**ITEM D.11** 917 Heights Blvd **Houston Heights South**

HPO File No. HP2022\_0064

### **CERTIFICATE OF APPROPRIATENESS**

New Carport with gym and storage on 2<sup>nd</sup> floor located at back of lot behind the main house with at 1,040 SF

<u>Detached Garage Ridge Height</u> (New Construction)

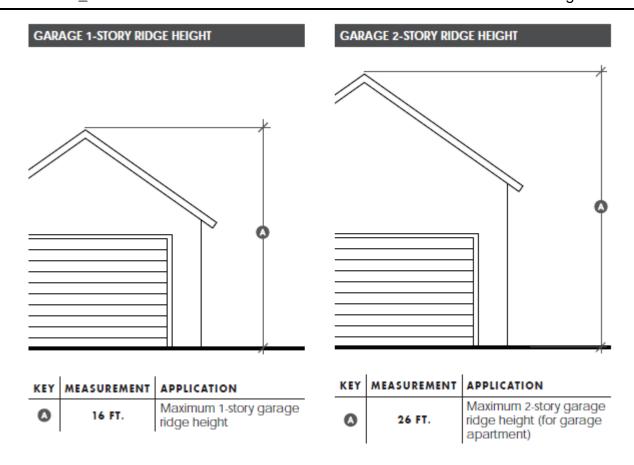
Proposed ridge height: 26' - Meets
